PRODUCT NOTICE — SNAPHOOKS

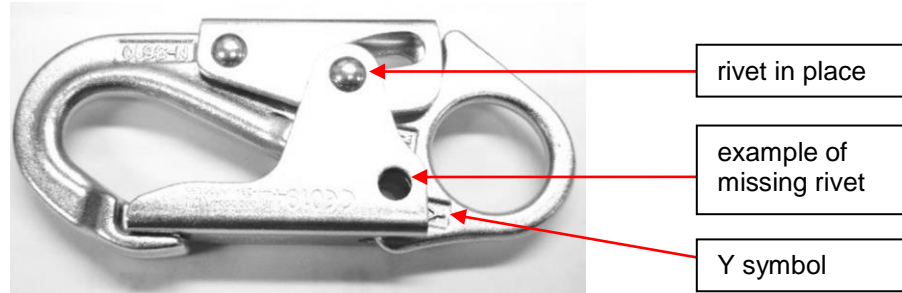
Capital Safety is aware of an assembly issue with snaphooks manufactured by a supplier. These snaphooks are widely used components in fall protection products. The issue concerns missing or improperly installed rivets (see photograph below). The manufacturer symbol is a stamped “Y” as shown in the photograph.

The picture above is a representative model snaphook – other models are also affected.

We want to remind users to conduct a pre-use inspection of all fall protection safety equipment prior to use as per instructions in the user manuals. If a missing or incompletely installed rivet is identified in a snaphook on a Capital Safety product, the product should be removed from service and returned via distribution for replacement under warranty. (See figure 1 & 2 below.)

Capital Safety has verified that the supplier implemented an appropriate corrective action program. The supplier’s notification (above) has an imbedded video demonstration of its revised process.
